### **REMARKS**

#### I. ALLOWABLE SUBJECT MATTER

#### II. OBJECTION TO THE DRAWINGS

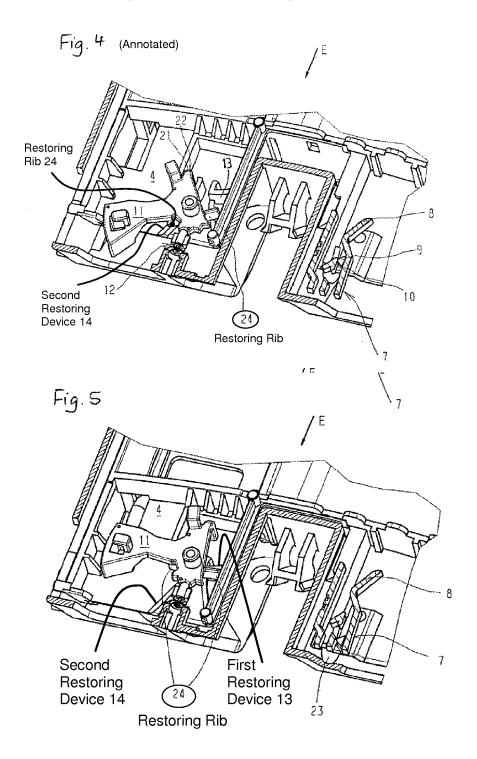
The Examiner objects to the drawings as failing to show how restoring rib 24 rides over the second restoring device 14 in order to maintain the mass 11 in the position shown in Figure 2. The Examiner refers especially to a figure showing the receptacle in the open position detailing the position of the safety locking mechanism with respect to the housing, as described in the specification.

As is shown in Figs. 4 and 5 of the present application, reproduced below, the drawings do in fact illustrate how the restoring rib 24 rides over the second restoring device 14. For the Examiner's convenience, the figures as shown herein have been annotated to include the specific callouts for the restoring rib 24 and the second restoring device 14 consistent with that shown in the other figures. Fig. 4 illustrates the mass 11 in the deflected position. Fig. 5, on the other hand, shows the mass 11

restored to the basic position (of Fig. 2) as a result of the restoring rib 24 riding over the second restoring device 14 and coming into contact with the first restoring device 13.

Consequently, applicant respectfully submits that the drawings already show how the restoring rib 24 rides over the second restoring device 14 in order to maintain the mass 11 in the position shown in Fig. 2.

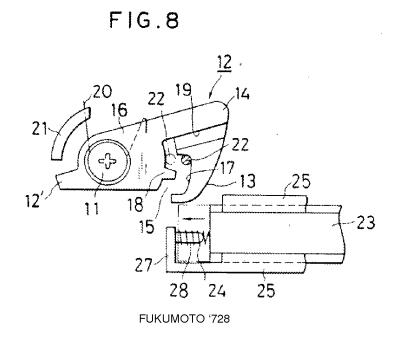
Referring to Fig. 8 of Fukumoto (reproduced herein), for example, the Examiner equates the cam lever 12 with the mass recited in claim 1.

The Examiner goes on to equate the inertia stopper 23 in Fukumoto with the engaging device recited in claim 1. The Examiner refers to coiled spring 24 as constituting the claimed restoring device.

In *Fukumoto*, cam lever 12 in conjunction with pin 22 of the moveable body 2 serves to provide a conventional push-push locking mechanism such as that described in the background section of the present application. (See, e.g., Col. 5, In. 9 to Col. 6, In. 2 of *Fukumoto*). The cam lever 12 itself does not provide a safety locking mechanism. That is why *Fukumoto* goes on to describe the feature of inertia stopper 23 in order to provide such safety function. (See, e.g., Col. 6, Ins. 3-16).

Nevertheless, to the extent the Examiner considers the cam lever 12 to be the mass as recited in claim 1, *Fukumoto* does not include an engaging device that holds the mass (cam lever 12) in the deflected position and a restoring device, effective in response to an overpressure applied to the receptacle or other object, to direct the mass (cam lever 12) as held by any engaging device in the deflected position, into the basic position.

Referring to Fig. 8, *Fukumoto* teaches that upon a sudden stop or collision, the inertia stopper 23 moves against the biasing force of the coiled spring 24 (shown in phantom in Fig. 8). Such movement brings the inertia stopper 23 into slide contact with the side surface of the backward end of the front inclined surface 13. This permits the pin 22 to escape from the recess 17, but the pin 22 cannot enter the straight upward slope 19 and, therefore, the moveable body 2 cannot move to its open position and is thus kept closed. (Col. 6, Ins. 51-68).

Thus, the inertia stopper 23 in *Fukumoto* does not function in accordance with the claimed engaging device as suggested by the Examiner. The inertia stopper 23 does not hold the mass (cam lever 12) in the deflected position such that the mass (cam lever 12) is subsequently returned to the basic (non-deflected) position by applying overpressure to the moveable body 2 as claimed. Rather, the inertia stopper 23 serves to deflect the cam lever 12 during a sudden stop or collision. The inertia stopper 23 by no means holds the cam lever 12 in the deflected position as it is clear in *Fukumoto* that the inertia stopper 23 immediately returns to its original position "as soon as the automobile is free from the force of inertia".
